3.7 PLANT SYSTEMS

3.7.1 Residual Heat Removal Service Water (RHRSW) System

FIGURE 4.1-1 (PAGE 1 OF 1)
SITE AND EXCLUSION AREA BOUNDARIES

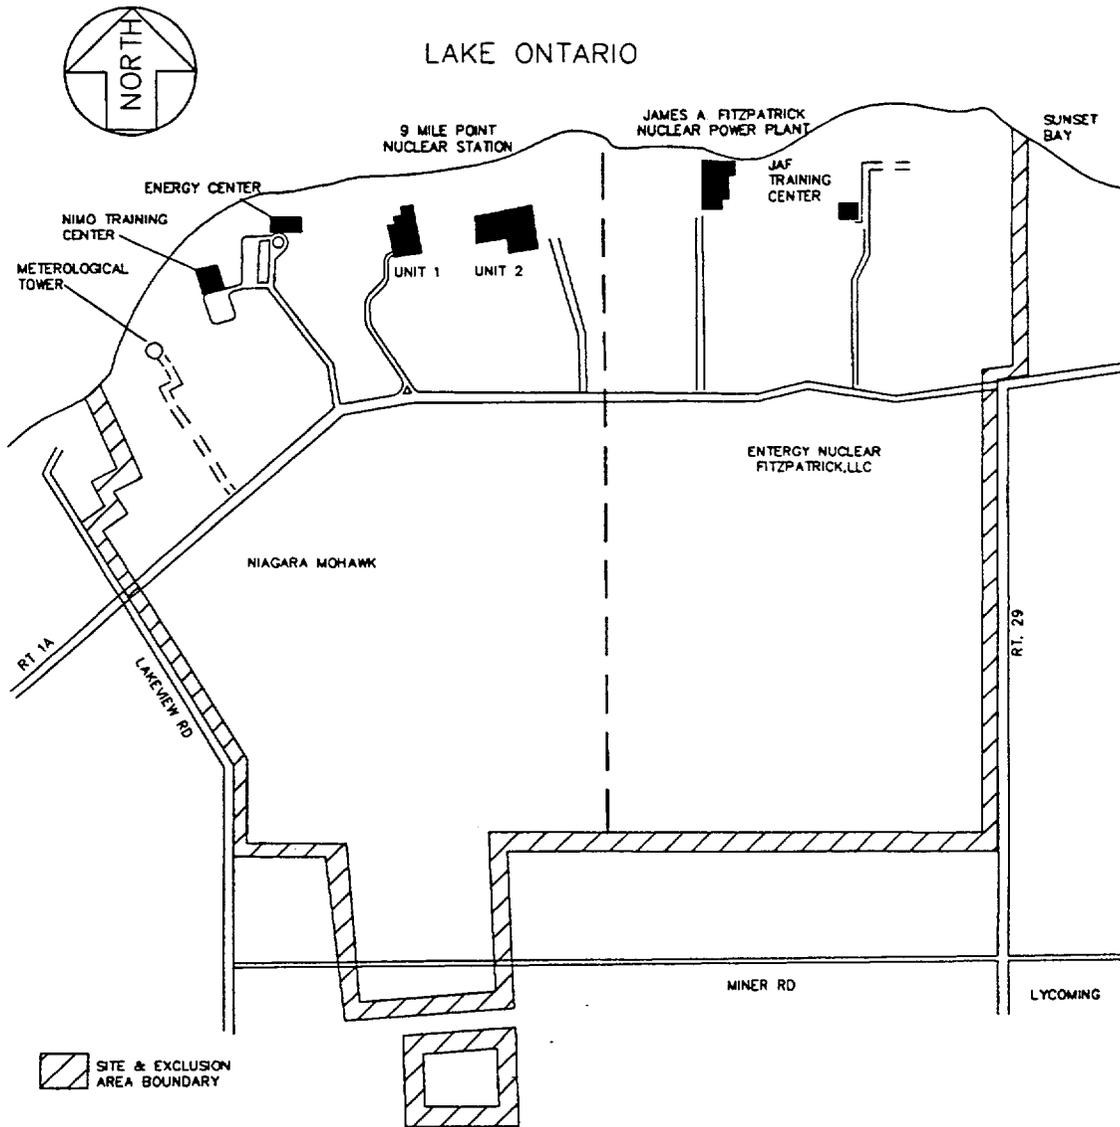
CTS correction
